# Access Compliance Report

## Public Rights-of-Way

### (Curb Ramps)

Intersection ID: N/A	Main Street: PINEVILLE-MATTHEWS_RD	Cross Street: N/A	Location: NE
ADA ID: F6230CCD7780	Ramp Type: PerpDiag	Initial Pass/Fail: Fail	Overall Compliance: No
			Severity Score: 33.75

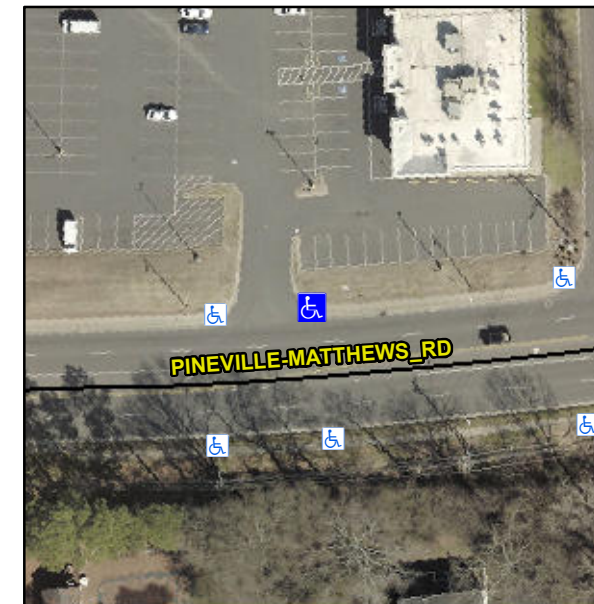
**Not Found, R304.5.1, R304.2.2, R304.5.3**

Compliance	Description	Data	Compliance	Description	Data
N/A	Ramp Length (in)	59.0	No	Ramp Slope (%)	9.9
No	Ramp Width (in)	40.0	No	Ramp XSlope (%)	6.2
N/A	Flare Type LT	N/A	N/A	Flare Type RT	N/A
N/A	Flare Slope LT (%)	N/A	N/A	Flare Slope RT (%)	N/A
N/A	Flare Traversable LT?	N/A	N/A	Flare Traversable RT?	N/A
N/A	Landing Length (in)	N/A	N/A	DWS Provided?	N/A
N/A	Landing Width (in)	N/A	N/A	DWS Contrast?	N/A
N/A	Landing Slope (%)	N/A	N/A	DWS Length (in)	N/A
N/A	Landing X Slope (%)	N/A	N/A	DWS Full Width?	N/A
N/A	Landing Curb? (Y/N)	N/A	N/A	DWS Offset (in)	N/A
N/A	Shared Landing?	N/A			
N/A	Gutter Ponding?	N/A	N/A	Gutter Slope (%)	N/A
N/A	Gutter Lip Ht (in)	N/A	N/A	Gutter X Slope (%)	N/A
N/A	Painted X Walk1?	No	N/A	Painted X Walk2?	No
	X Walk 1 Direction	To W		X Walk 2 Direction	To S
N/A	X Walk 1 Width (in)	N/A	N/A	X Walk 2 Width (in)	N/A
	X Walk 1 Slope (%)	4.2		X Walk 2 Slope (%)	1.8
	X Walk 1 X Slope (%)	1.9		X Walk 2 X Slope (%)	4.2

**Remove & Replace Curb Ramp With Two New Directional Ramps or Equivalent.**
